**SUBJ:** **New Bid Opening Date, Clarifications to the Specifications and Responses to Vendor's Questions**

**BID ITEM:** **Bid Item #24-203 Taxiway F Reconstruction for Augusta, GA - Augusta Regional Airport**

**ADDENDUM NO. 1**

SHEET CONTENTS  
TYPICAL SECTIONS

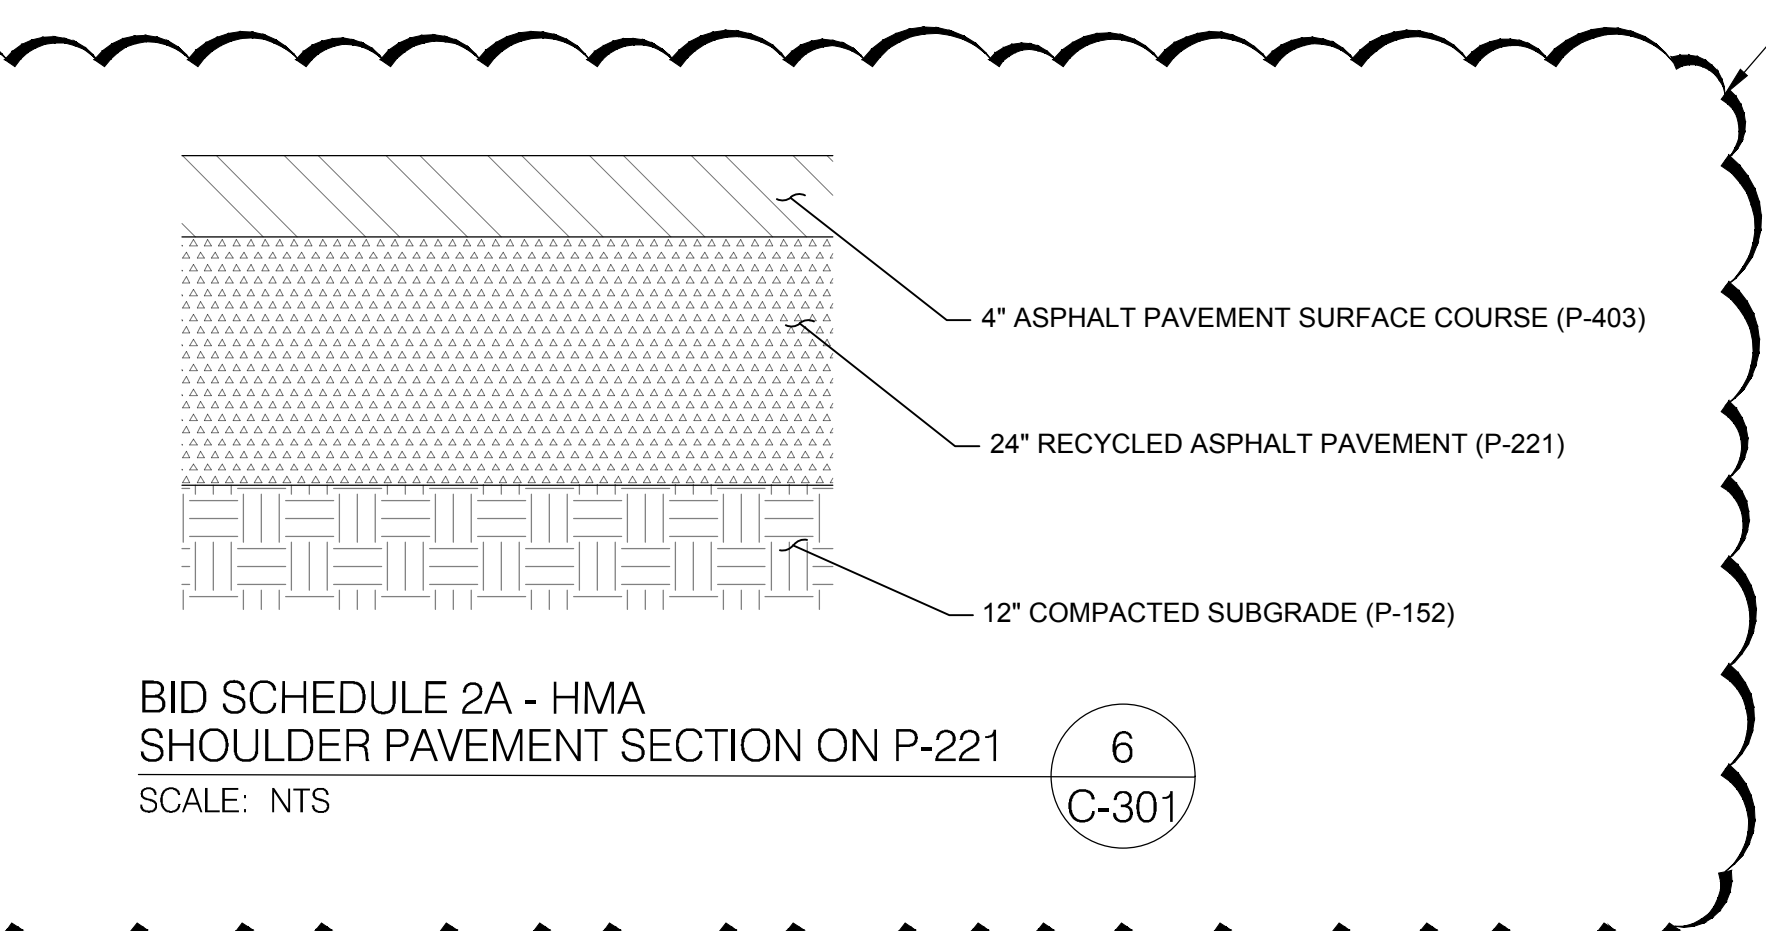
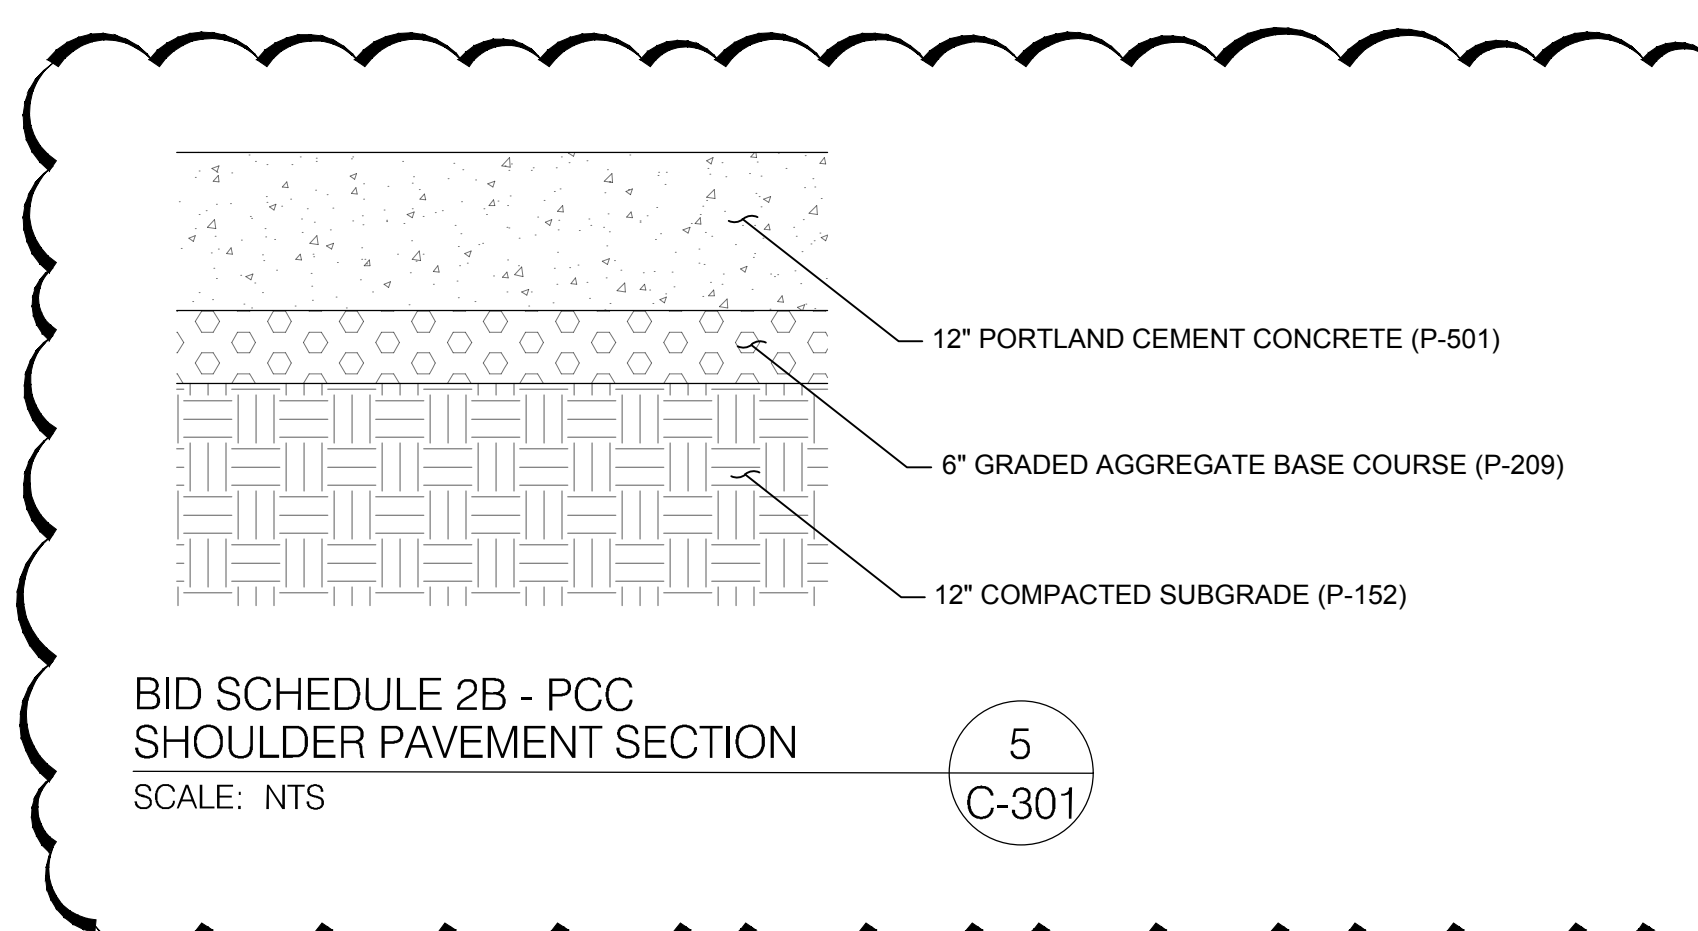
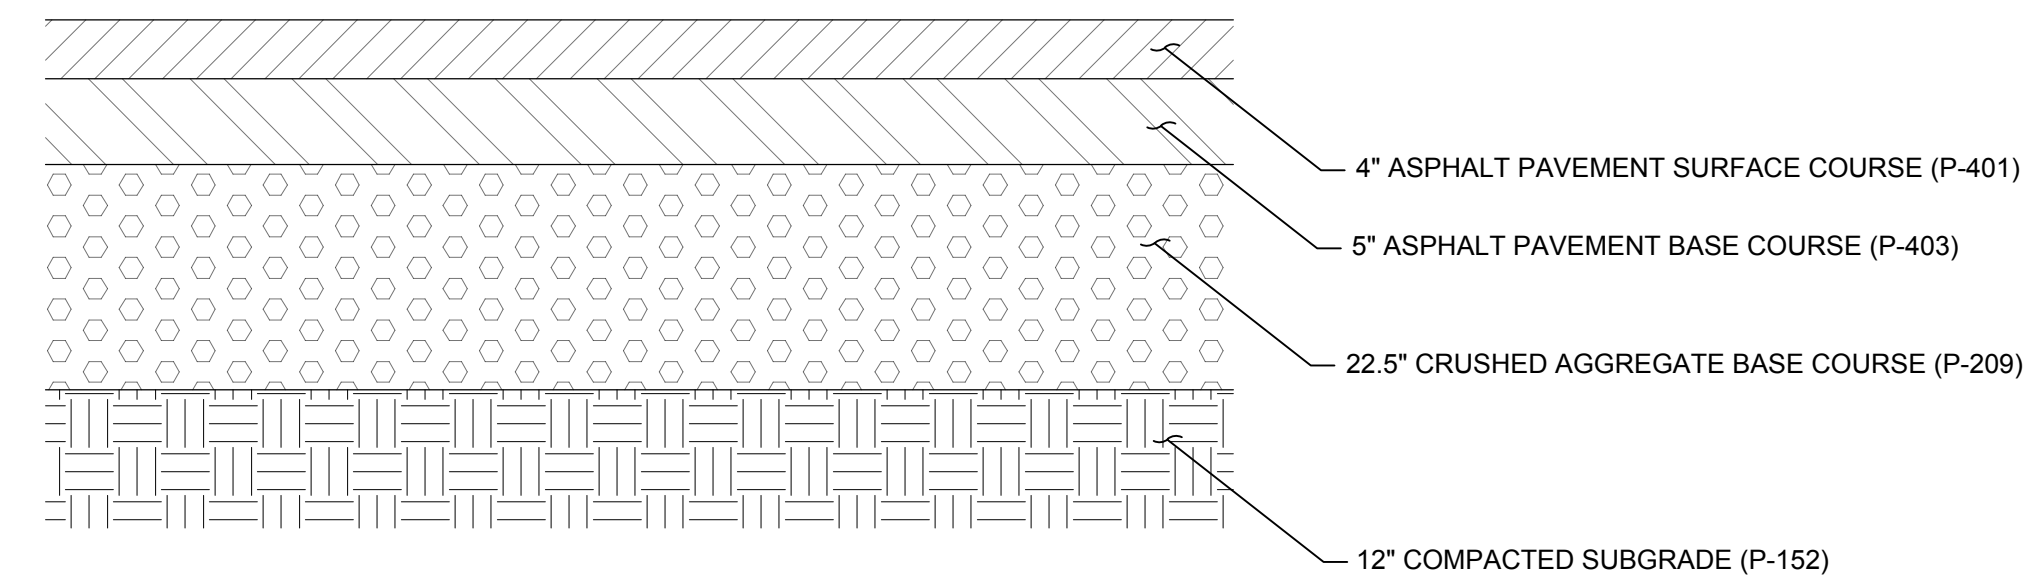
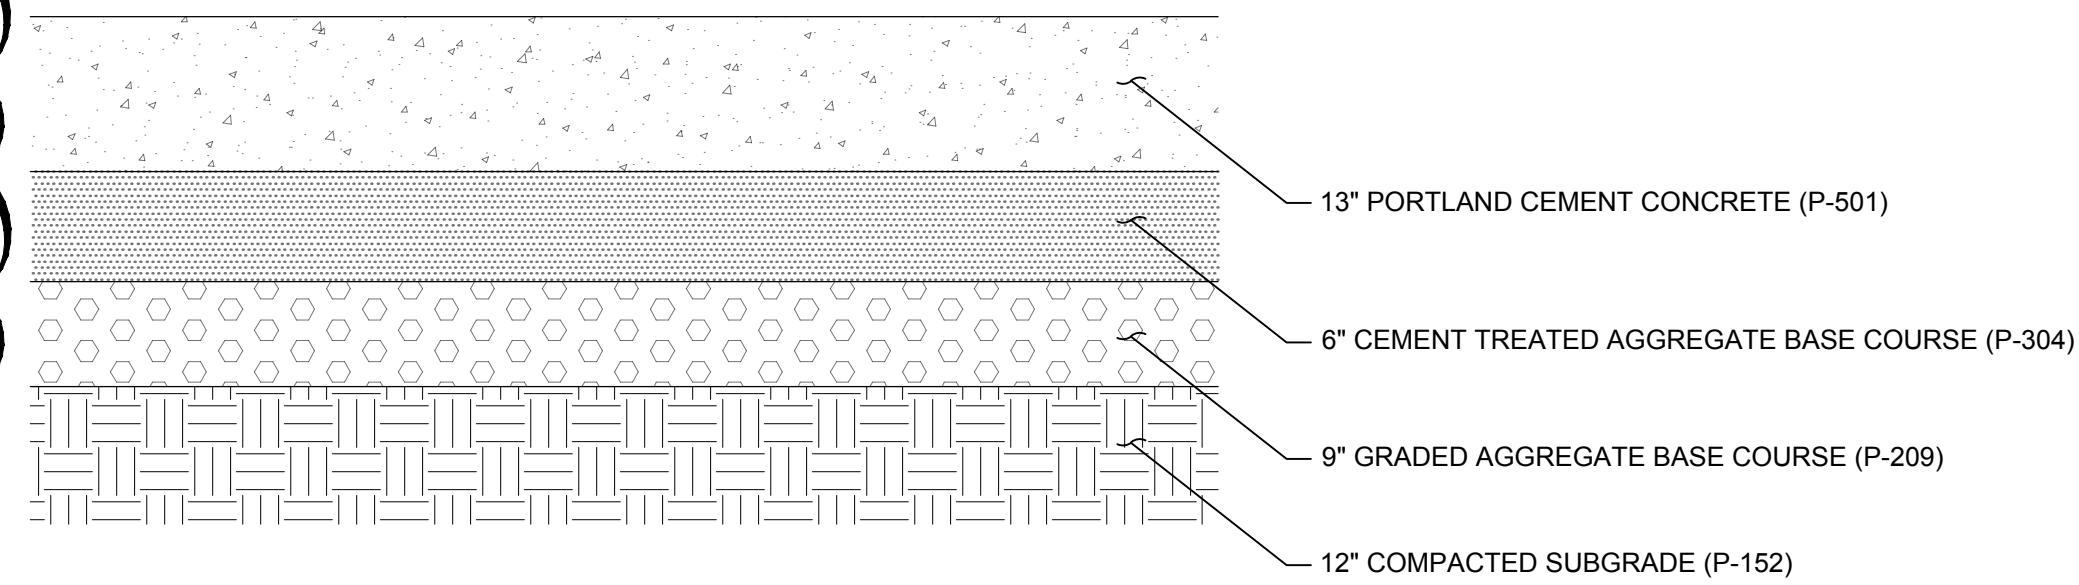
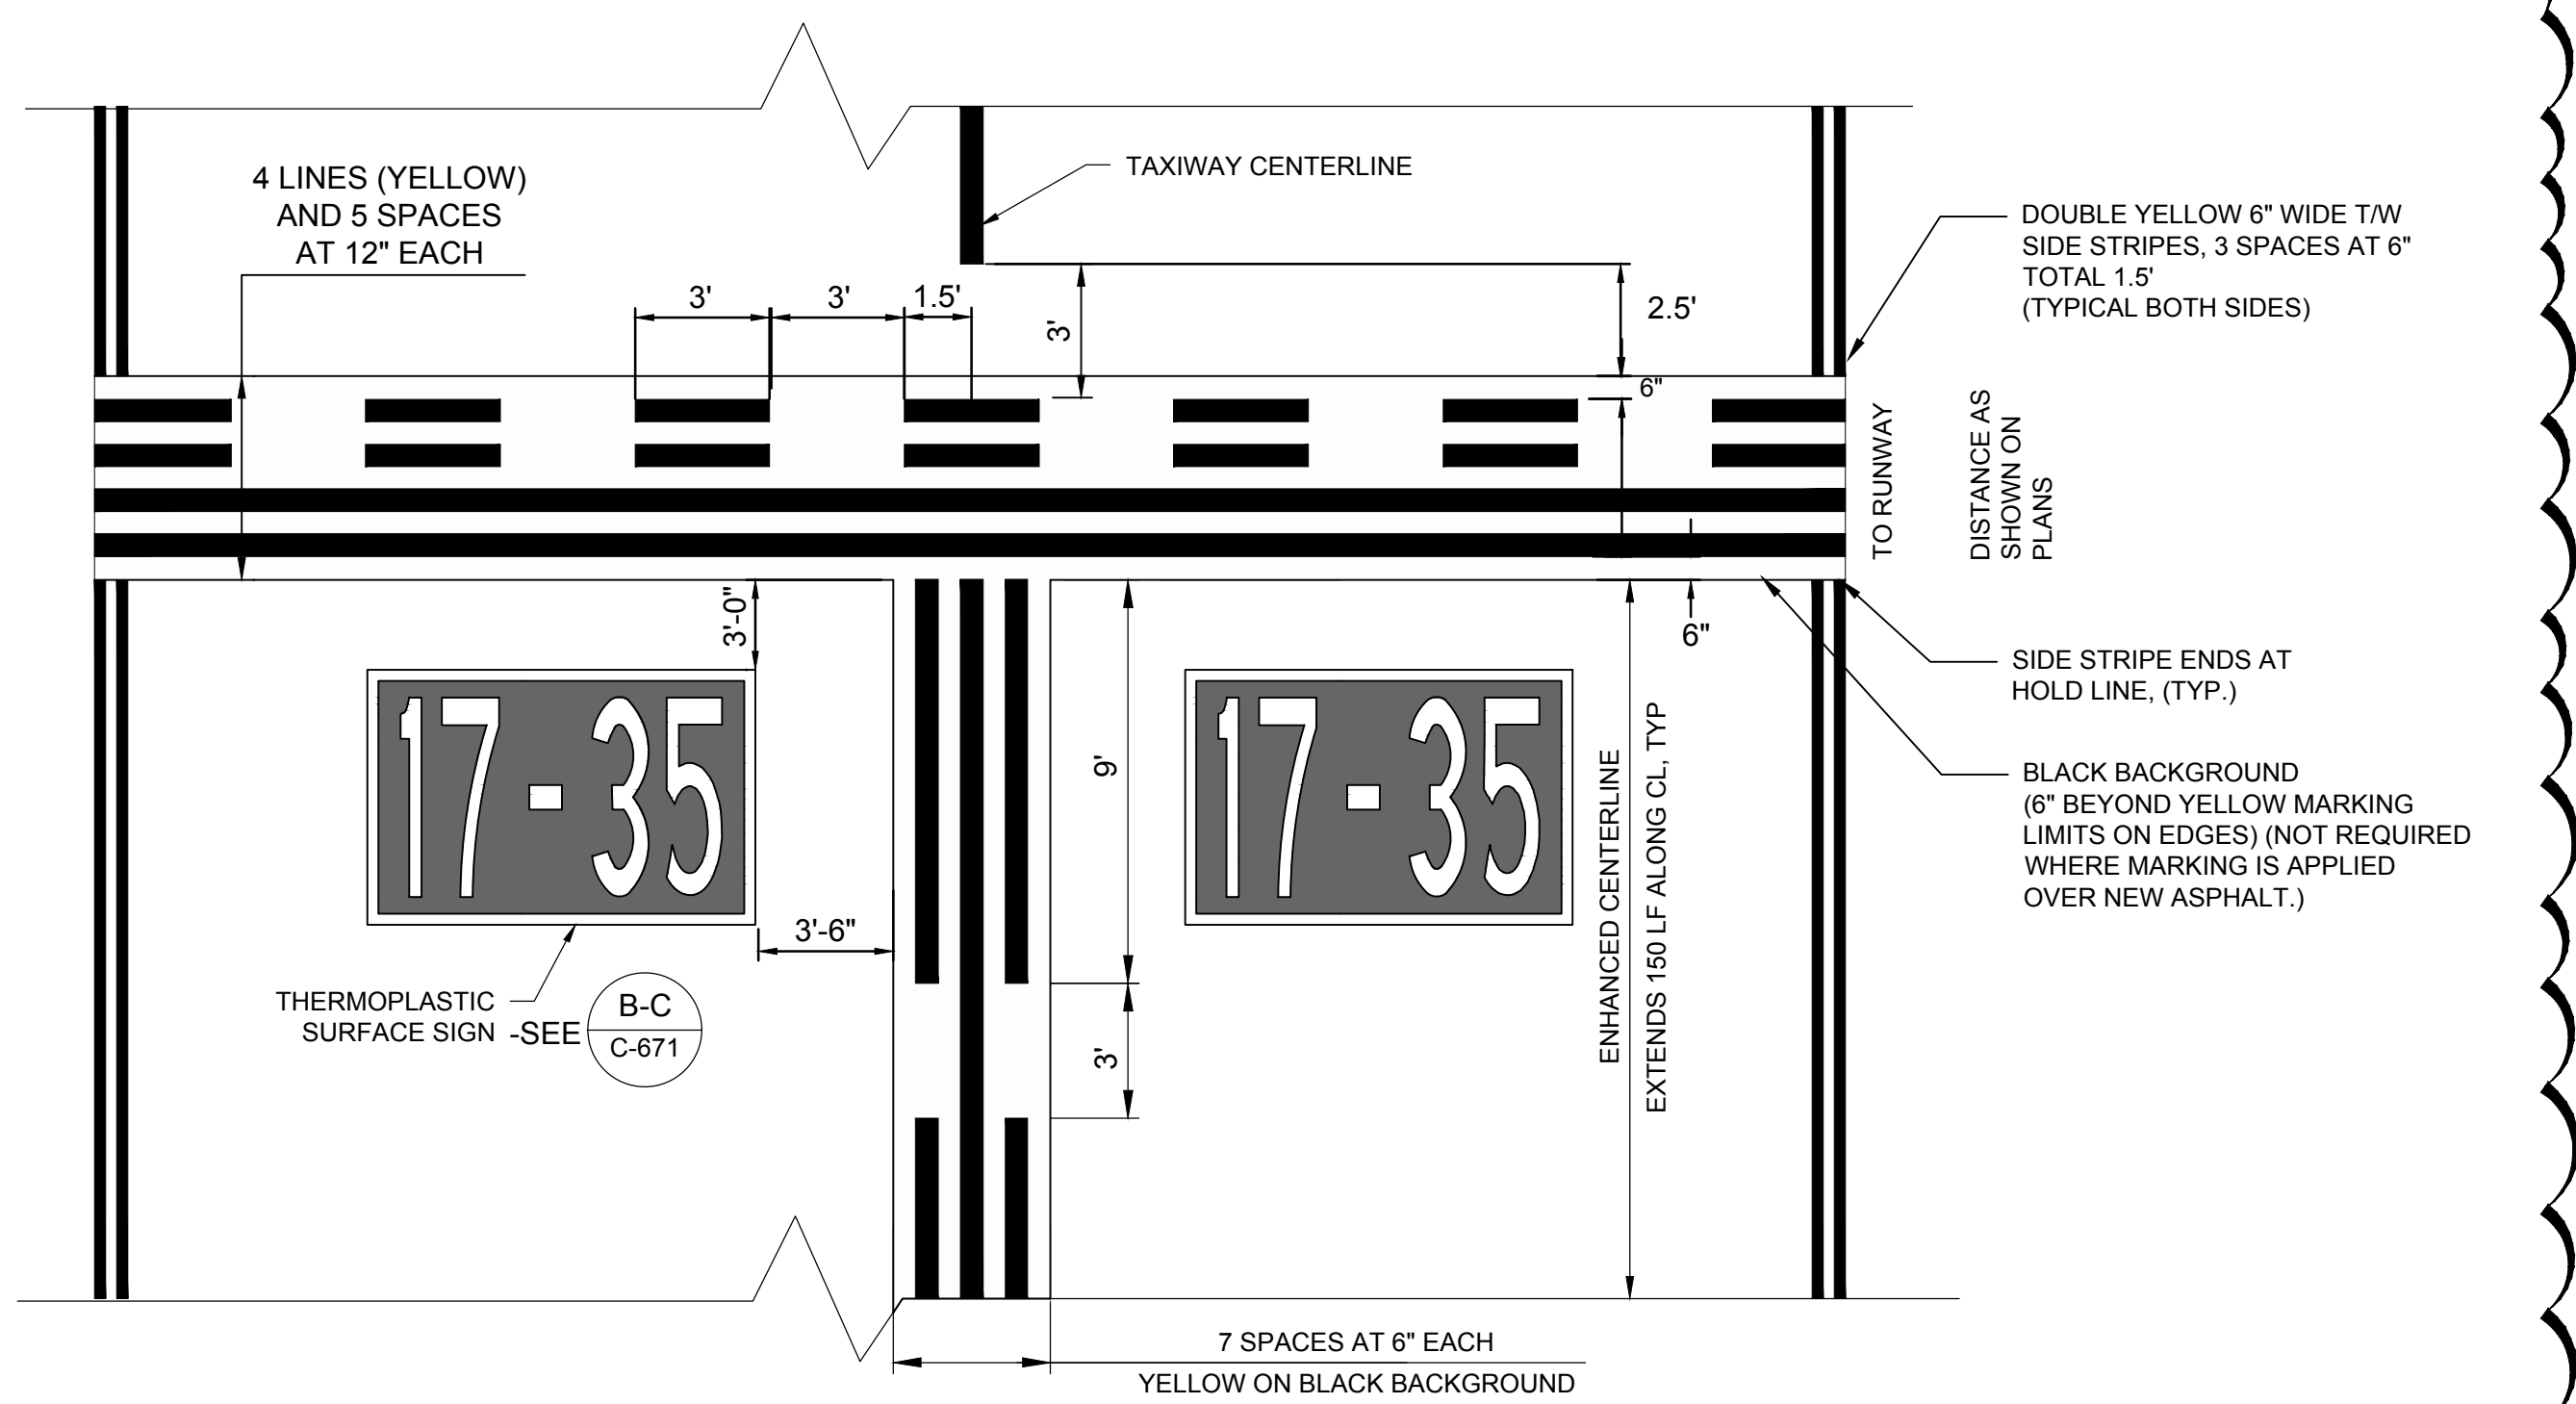
**Response: Concrete batch plant shall be located in either the primary or secondary staging areas as shown on G-081.**
41. Question: C-301, Note 3.  
**Response: Please refer to the Construction Drawing changes referenced in this Addendum #1.**

1. **Sheets G-061:** Updated and revised sheet to match bid tabs. **Delete** sheet G-061 and **replace** with revised sheet G-061 attached to this Addendum No. 1.
2. **Sheet C-301:** Updated and revised sheet to match the project and material definitions as defined in the project manual. **Delete** sheet C-301 and **replace** with revised sheet C-301 attached to this Addendum No. 1.
3. **Sheet C-671:** Updated detail callout. **Delete** sheet C-671 and **replace** with revised sheet C-671 attached to this Addendum No. 1.

**1** ENHANCED TWY CENTERLINE MARKING AND HOLD LINE  
NOT DRAWN TO SCALE

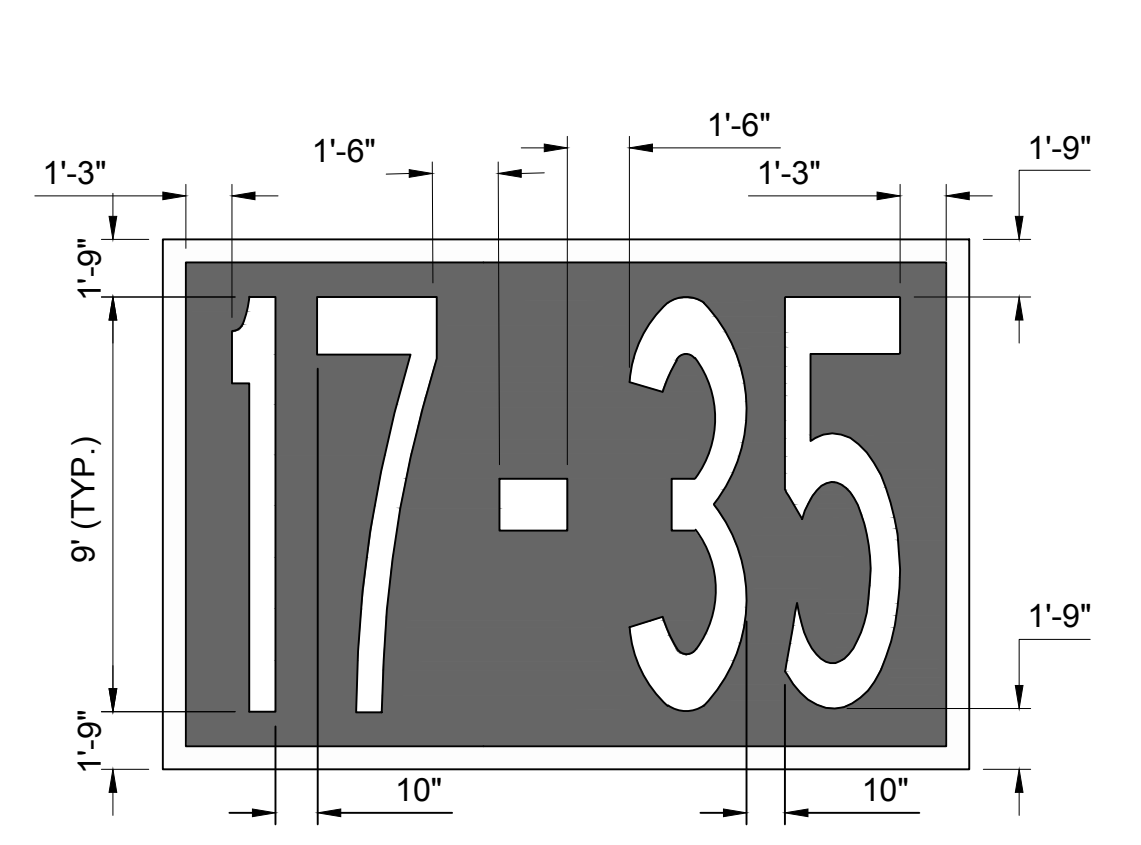
47. Question: General: Is the double row of silt fence measured separately for payment?  
**Response: No.**
48. Question: Bid Schedule: There are 4 EA preformed surface signs but plan sheet C-671 Detail 1 also shows thermoplastic hold lines. Are these required, and how will they be paid if so?

**this Addendum #1. Hold line shall be surface painted.**
